ADDENDUM NO. 2

NEW GYMNASIUM ADDITION TO MONTEVALLO HIGH SCHOOL

Architect Job No. 25-33

December 8, 2025

**1** PRESSURE PIPING - FLOOR PLAN
1/8" = 1'-0"

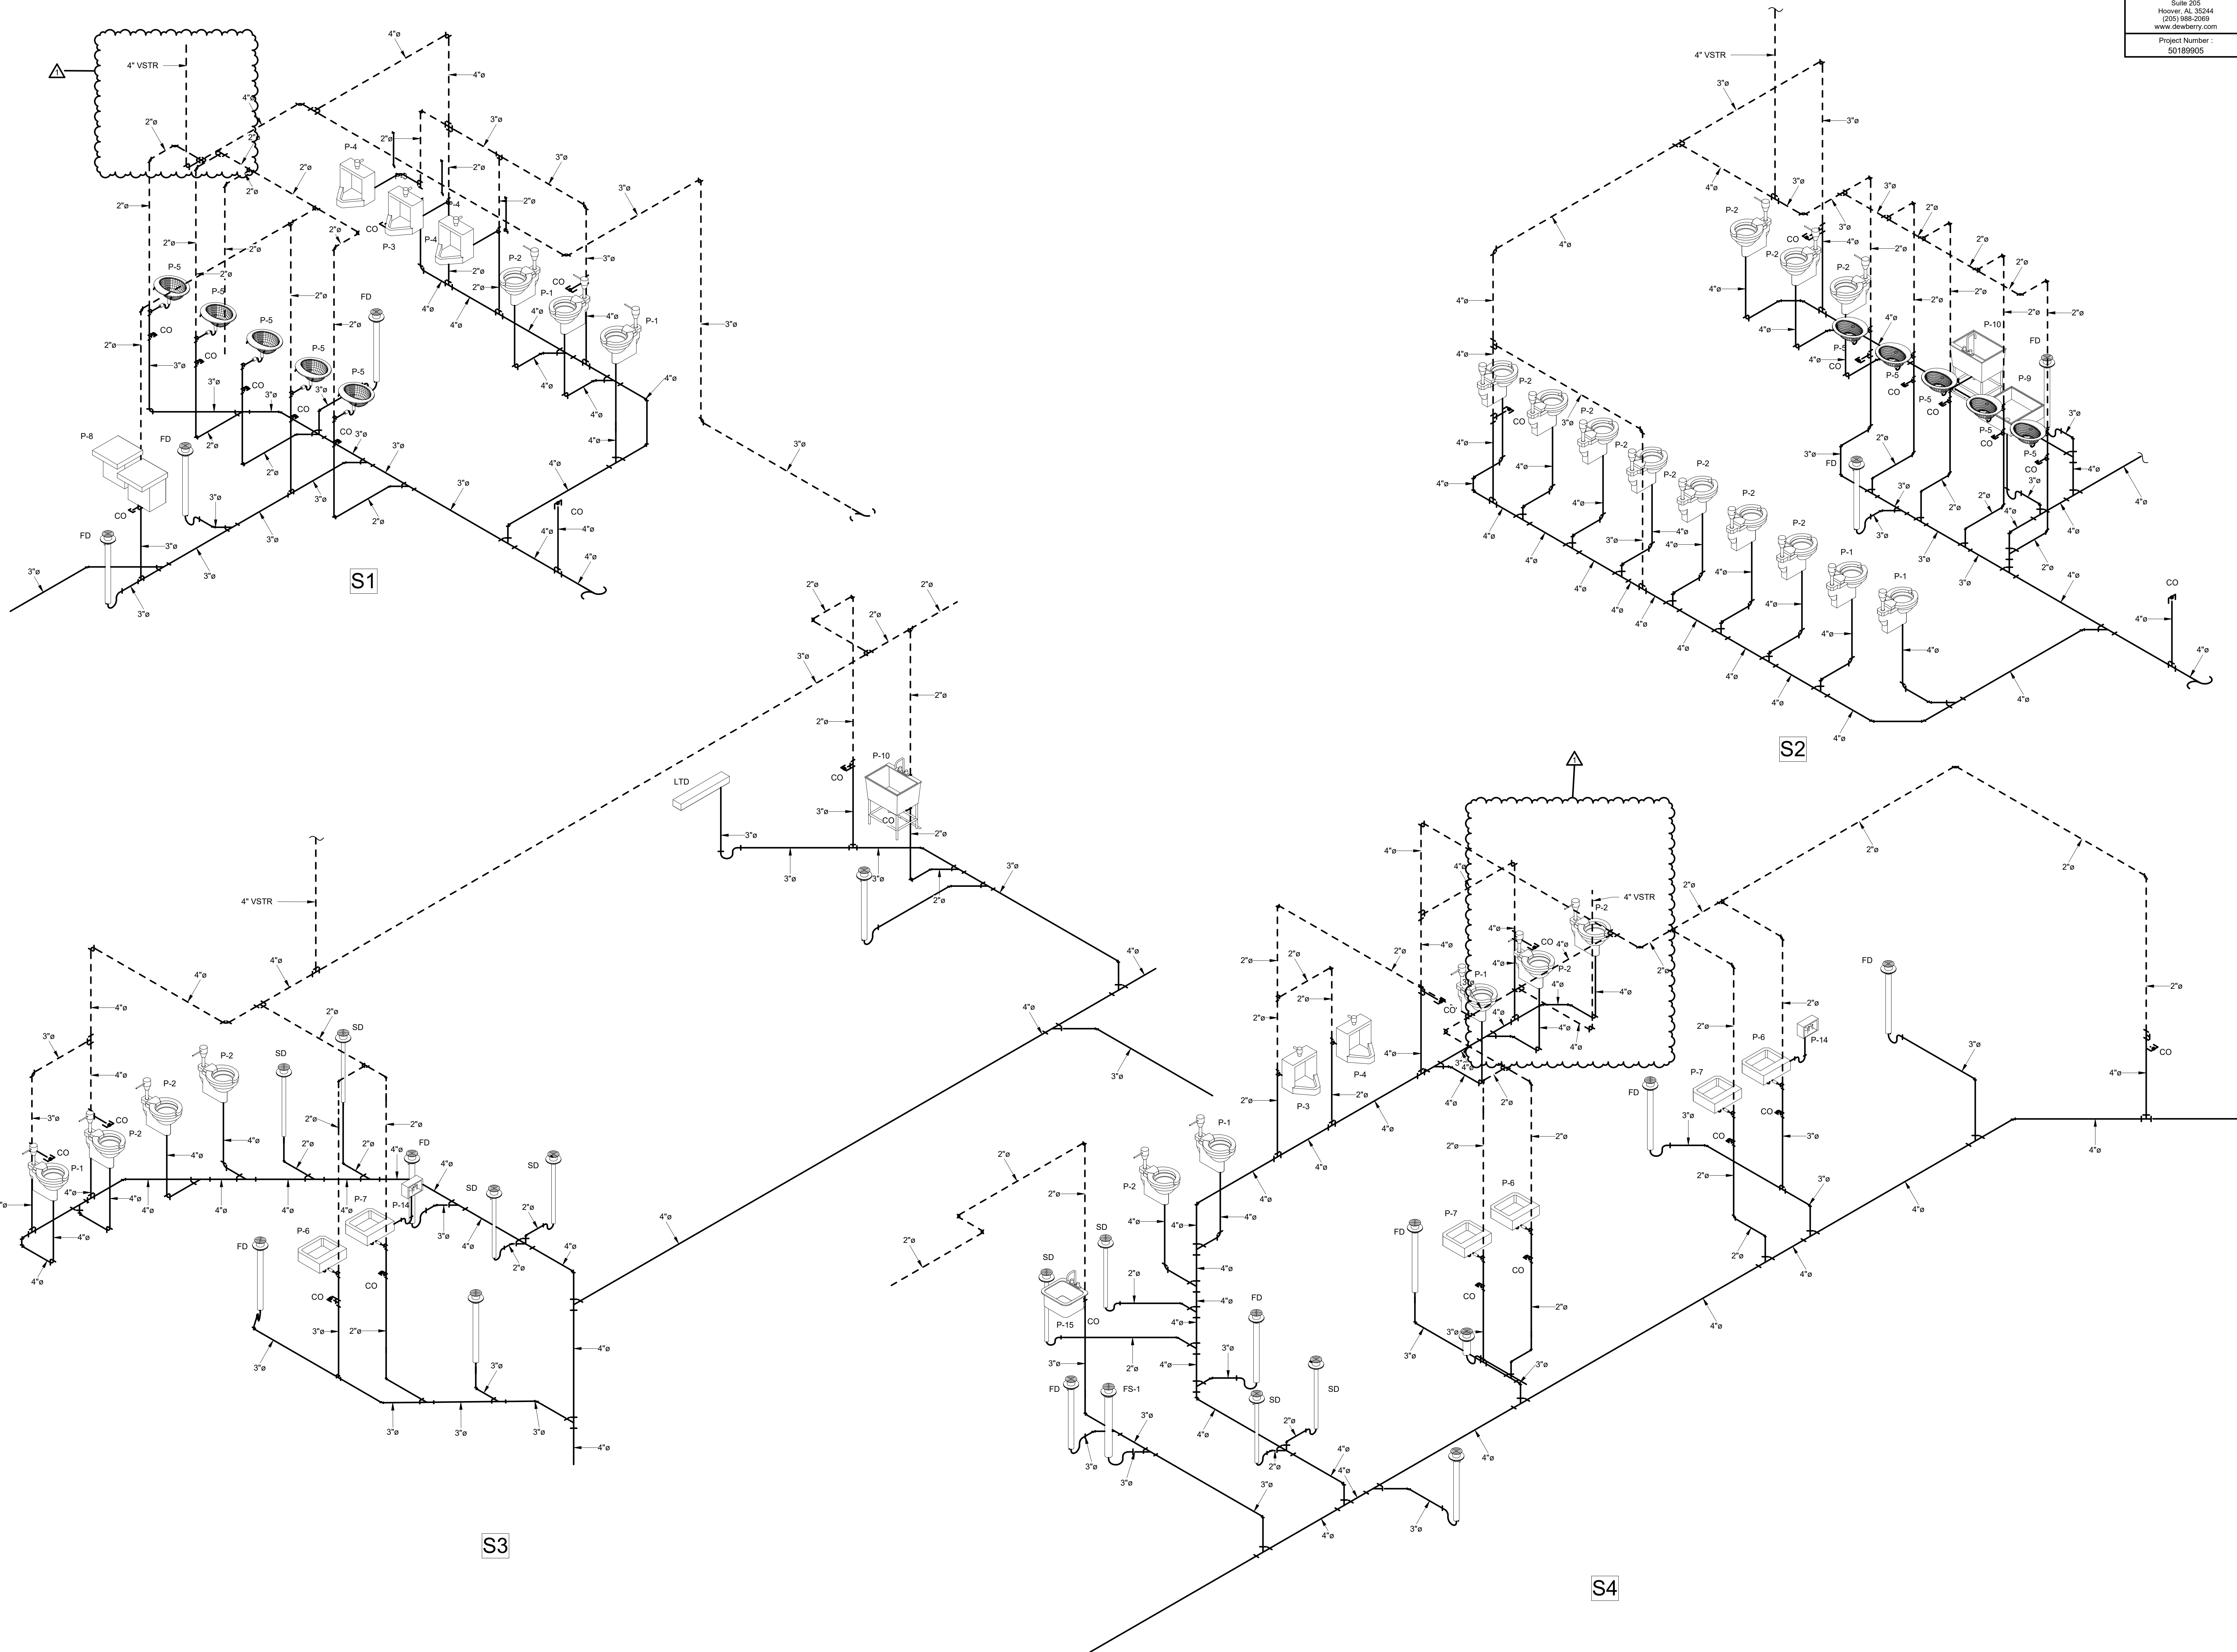
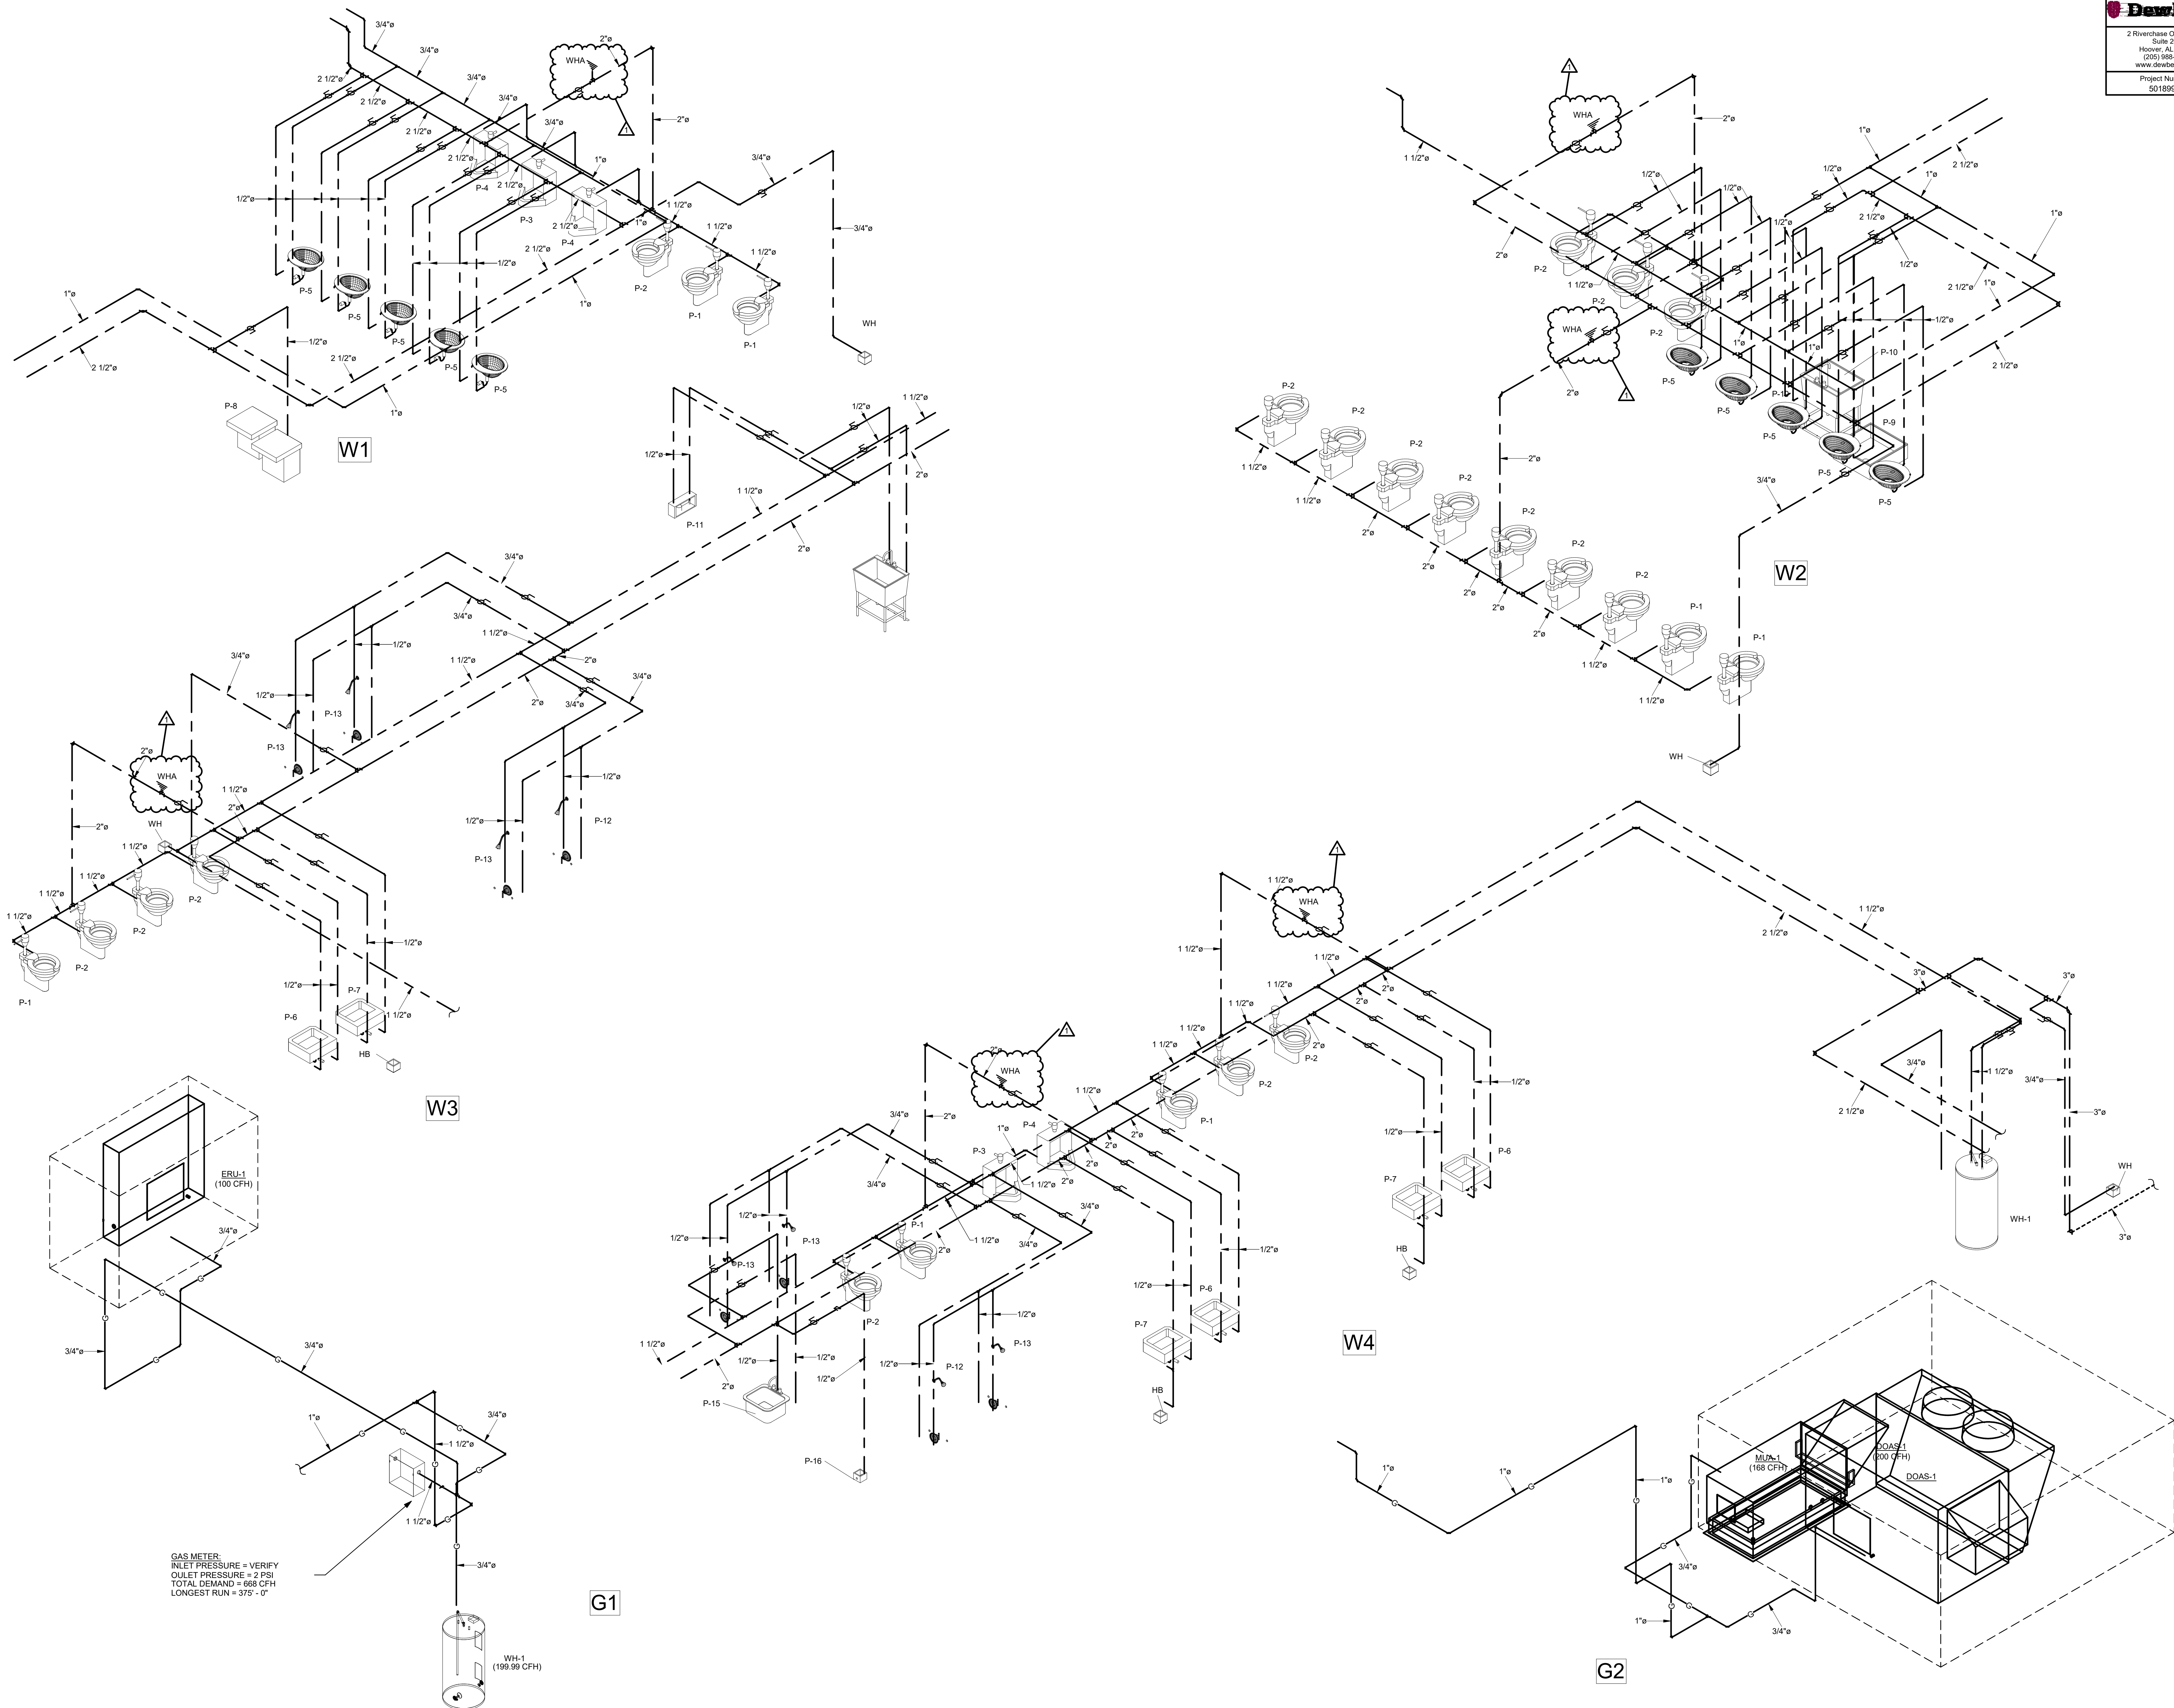
18. **Sheet P3.0** – Revised pipe sizes in Men A101.
19. **Sheet P4.0** – Revised vent piping.
20. **Sheet P5.0** – Revised vent piping and piping sizes.
